SUBDIVISION REVIEW SHEET**CASE NO.:** C8-2020-0021.0A**COMMISSION DATE:** April 27, 2021**SUBDIVISION NAME:** Fort Branch Subdivision**ADDRESS:** 5016 E. Martin Luther King Jr. Blvd.**APPLICANT:** Robert Penta**AGENT:** Jerome Perales (Perales Land Development LLC)**ZONING:** SF-3-NP (single family residence)**NEIGHBORHOOD PLAN:** MLK-183**AREA:** 2.9 acre (30,642 sf)**LOTS:** 6**COUNTY:** Travis**DISTRICT:** 1**WATERSHED:** Fort Branch**JURISDICTION:** Full Purpose**VARIANCES:** none**DEPARTMENT COMMENTS:**

CITY OF AUSTIN –DEVELOPMENT SERVICES DEPARTMENT
SUBDIVISION APPLICATION – MASTER COMMENT REPORT

CASE NUMBER: C8-2020-0021.0A
 REVISION #: **00** UPDATE: U0
 CASE MANAGER: Cesar Zavala PHONE #: 512-974-3404

PROJECT NAME: Fort Branch Creek Subdivision
 LOCATION: 5016 E MARTIN LUTHER KING JR BLVD

FORT BRANCH CREEK SUBDIVISION

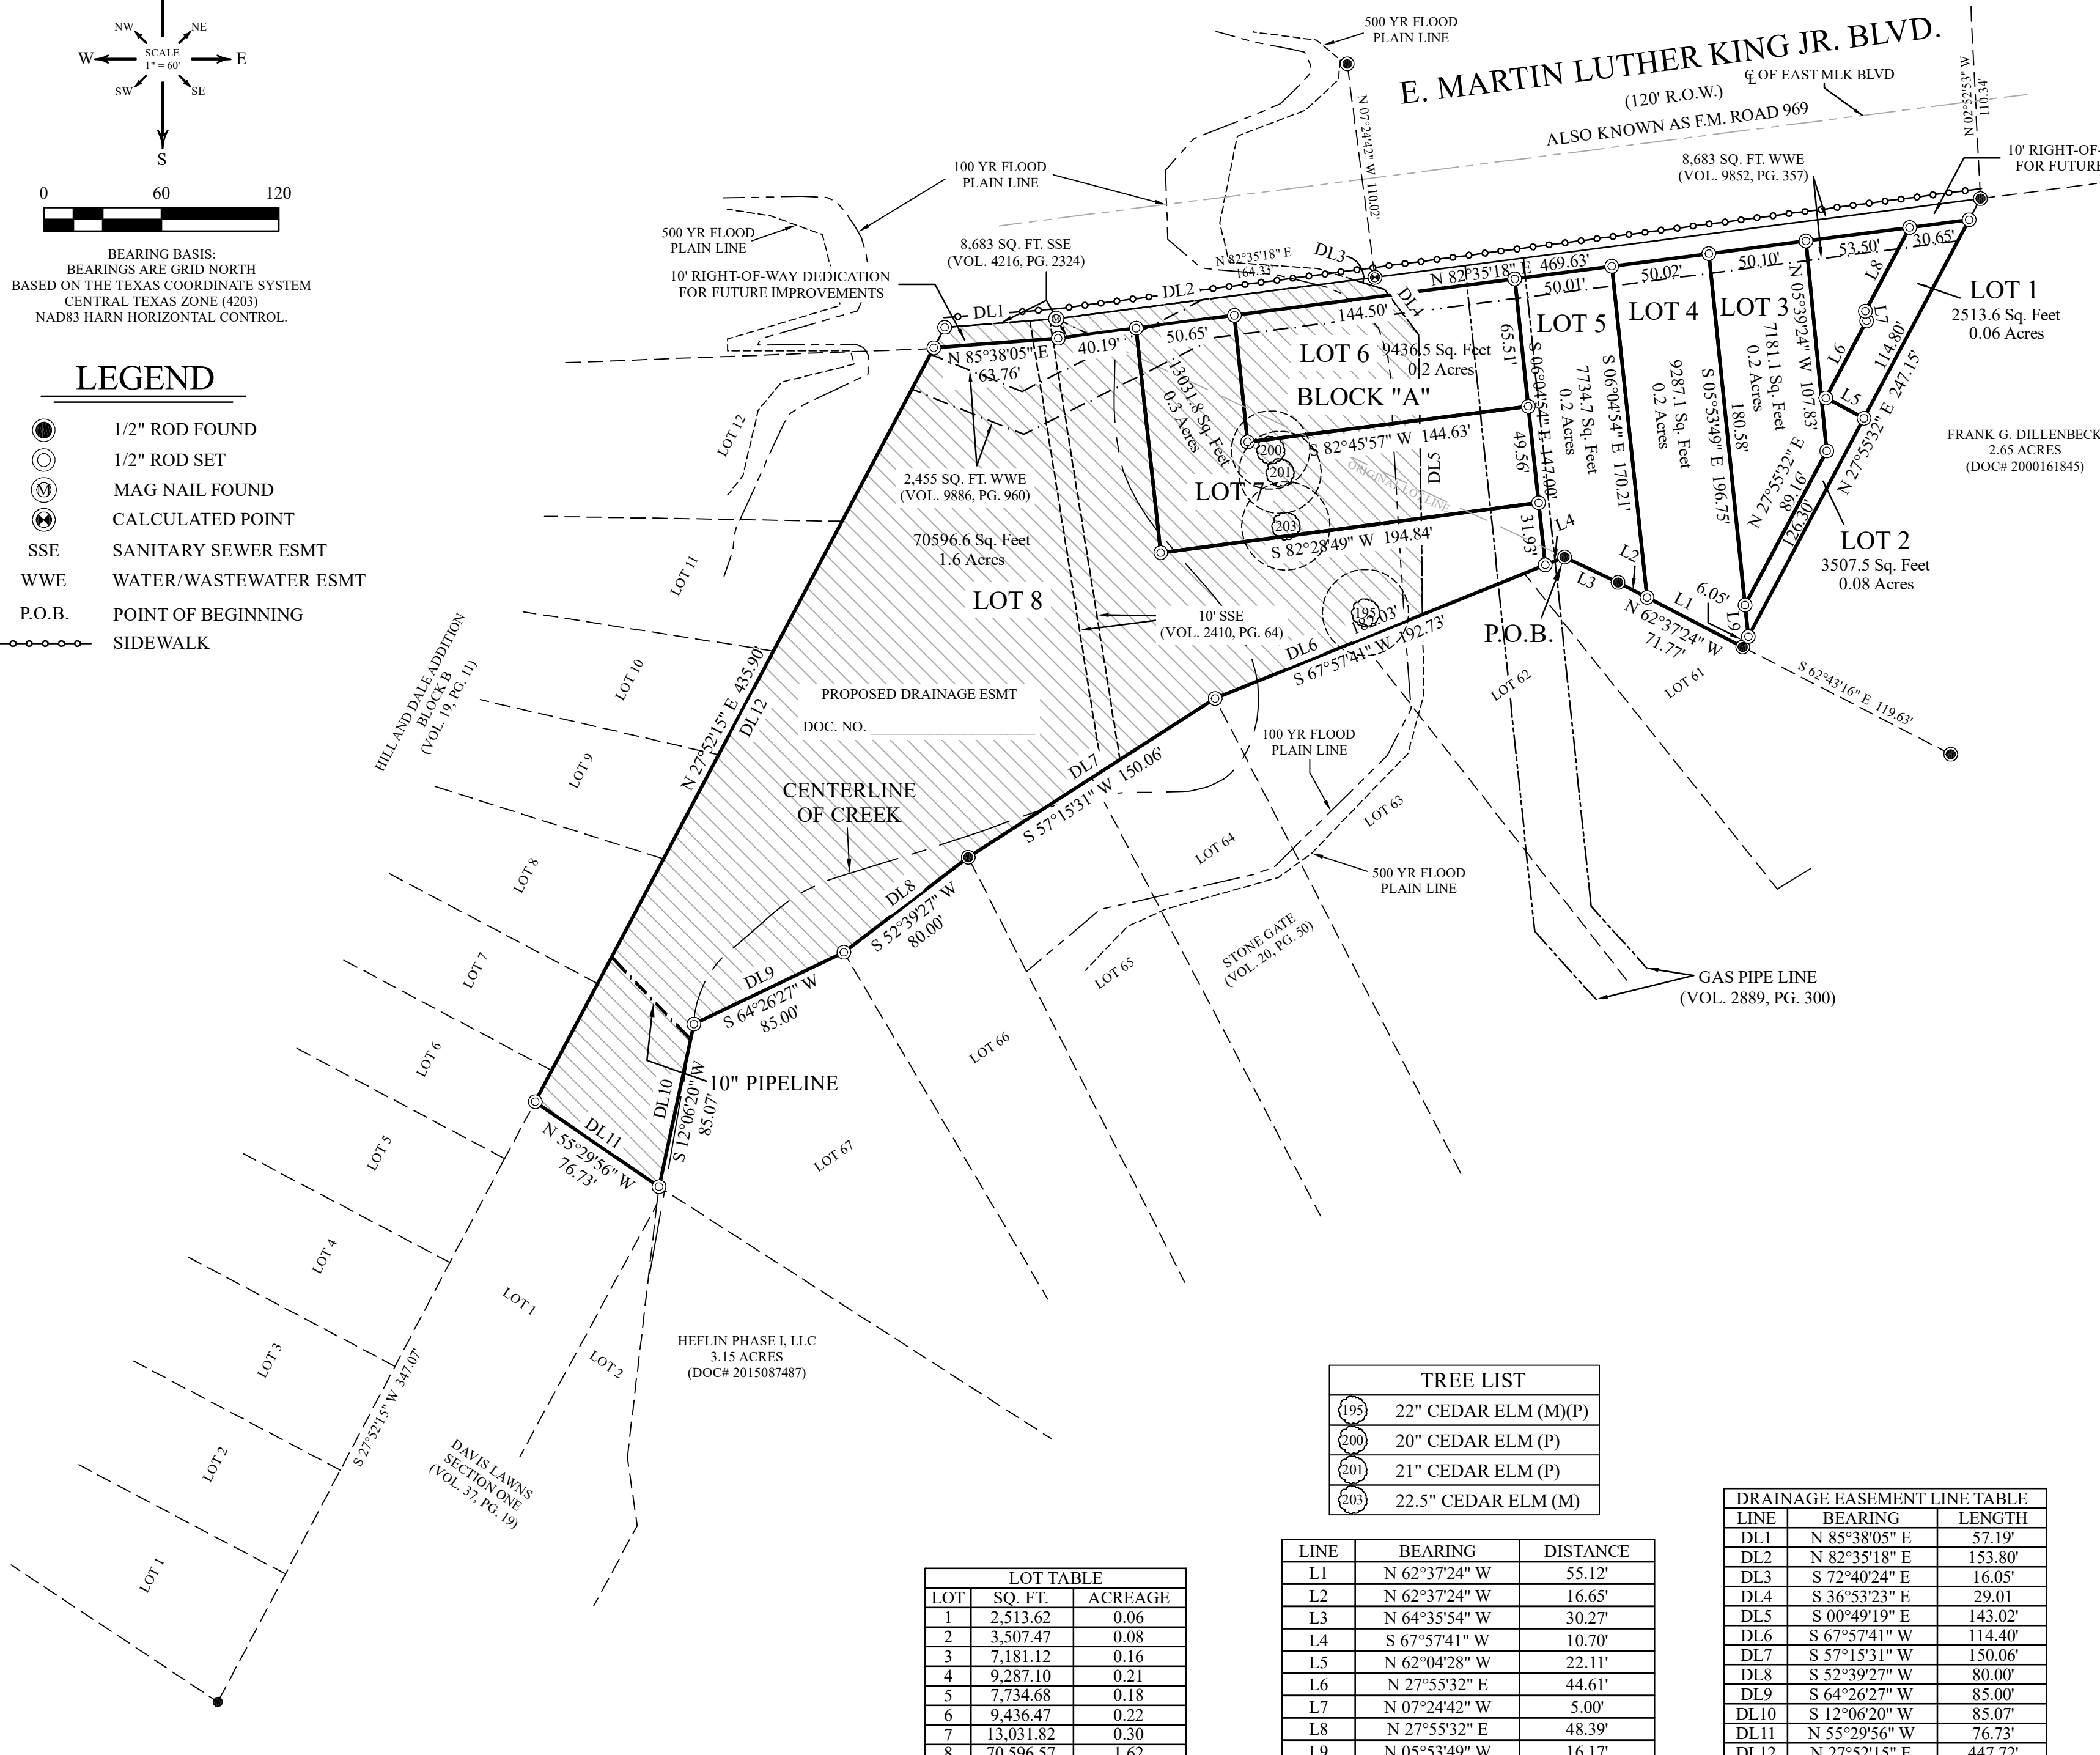
Fifteen foot electric distribution, electric telecommunications, and electric fiber easement is required adjacent to E MLK ROW. Show the easement on the face of the plat.

DE 1. Remove floodplain delineations from the plat in accordance with DCM 1.2.6.

DE 2. Provide confirmation from the floodplain reviewer that the fully developed 100 year floodplain will be contained within the drainage easement.

DE 3. Revise the floodplain certification note to read as follows:

DE 4. The drainage easement for the floodplain is shown to be dedicated by separate instrument. Why are you not dedicating it with the plat? If not, the separate instrument document will need to be submitted for review.

DE 5. The subdivision drainage and water quality controls will need to be contained also in a drainage easement to be shown on the plat, with conveyance to the floodplain in a drainage easement.

DE 9. Revise the notes #4,5 and 6 to be gender neutral.

DE 10. Remove notes #14, 16 and 21 along with any other notes that are not applicable and current.

- SR 1. Show all existing easements on the plat, annotate easements accordingly if provided by separate instruments. (L.D.C 25-1-83)
- SR 2. The plat is demonstrating a gas pipeline are, verify if the plat should comply with the Hazardous Pipeline section of the Land Development Code, Sections 25-4-134 and 25-2-516. If the pipeline meets the definition of a Hazardous Pipeline, the lots will need to comply with lot sizes as stated in 25-4-134(D) and other requirements as listed by code. A sign off or acknowledgement that the pipeline is not considered a Hazardous Pipeline will be needed from the Fire Department reviewer to clear this comment.

- SR 3. The property is zoned SF-3, minimum lots size for the zoning category is 5,750 square feet. Verify that the lots on the plat meet the zoning criteria. (L.D.C 25-1-83 / [25-2-492](#))

- SR 4. Lots should have a minimum width of 50 feet starting at the front building setback line ending 10 feet towards the rear of the lot. Verify that the lots meet the lot width requirement, as shown Lots 1, 2 and 6 do not meet the lot width requirement. L.D.C. [25-1-22\(C\)](#)

- SR 5. Remove the dashed lined annotating an original lot line. (L.D.C 25-1-83)
- SR 6. Show measurements for all lot lines on the plat.
- SR 7. Clarify if Lot 2 extends to East M.L.K between Lot 1 and Lot 3. If this is correct show a callout of the area between Lot 1 and Lot 3 showing that Lot 2 is part of the triangular area along the road to show frontage for the lot. Lots not having frontage to an existing roads require a commission approved variance to finalize a plat. L.D.C [25-4-171](#)

- SR 8. Add the lot totals on the Lot Table. (L.D.C 25-1-83)
- SR 9. The property description and survey notes can be removed from Sheet 1, this information is not needed on the plat for recording in Travis County.

- SR 10. Show the application submittal date on the plat, March 29, 2021. (L.D.C 25-1-83)

SR 11. Include the case number on the lower right corner of each plat sheet, C8-2020-0021.0A. (LDC 25-1-83)

SR 14. Update the owner’s dedication statement on Sheet 2 as follows: 25-1-83, TX 212.004(c)

WQ 1. Remove note #19 and replace with the following note:

Reference for comment #3

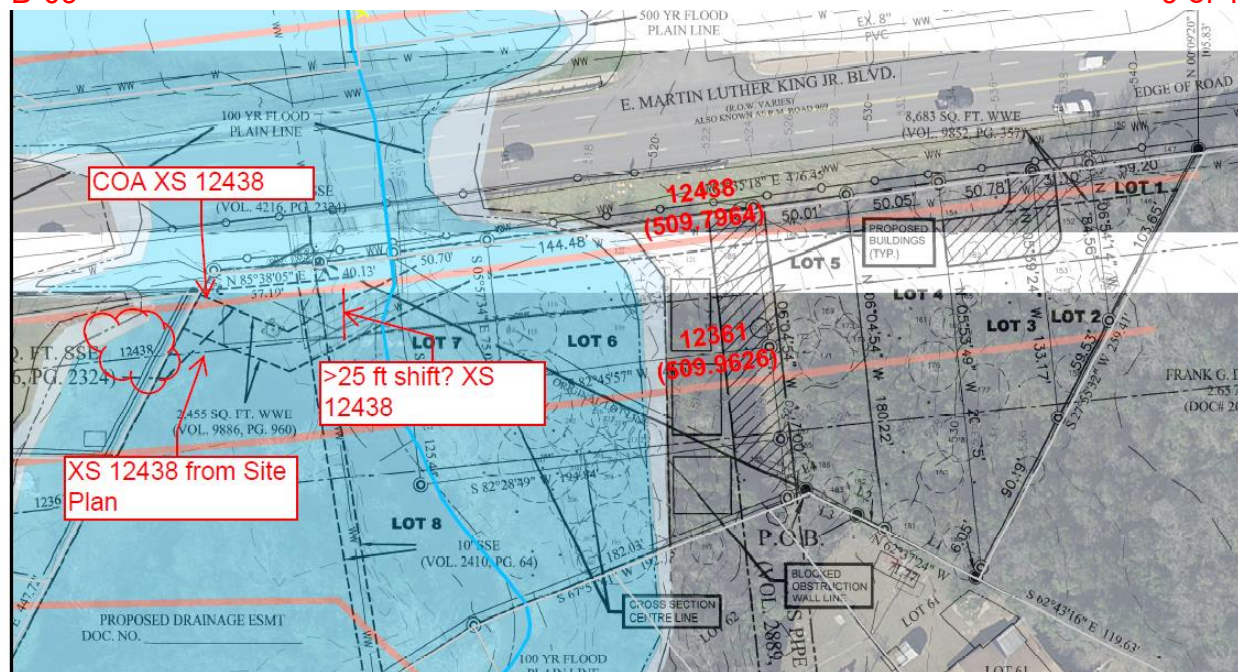
3. If the COA floodplain models were altered for this project, a project assessment is required. Looking at the submittals, it appears that FEMA 500- year floodplain is being used in place of Atlas 14 100-year and the floodplain/drainage easement is proposed to be dedicated accordingly. However, this cannot be confirmed and verified, since there seemed to be a shift in HEC-RAS cross sections in Exhibit 11 (please see the snip at the end of the FP comments below). Please double check the RS of those cross sections and other components of the models and explain the shift. It also helps to verify the delineation quickly if the applicant provides the shape files of HEC-RAS XS, 100-yr and 500-yr FP, and the Georeferenced site plan image used to plot in the plan sheets and exhibits.
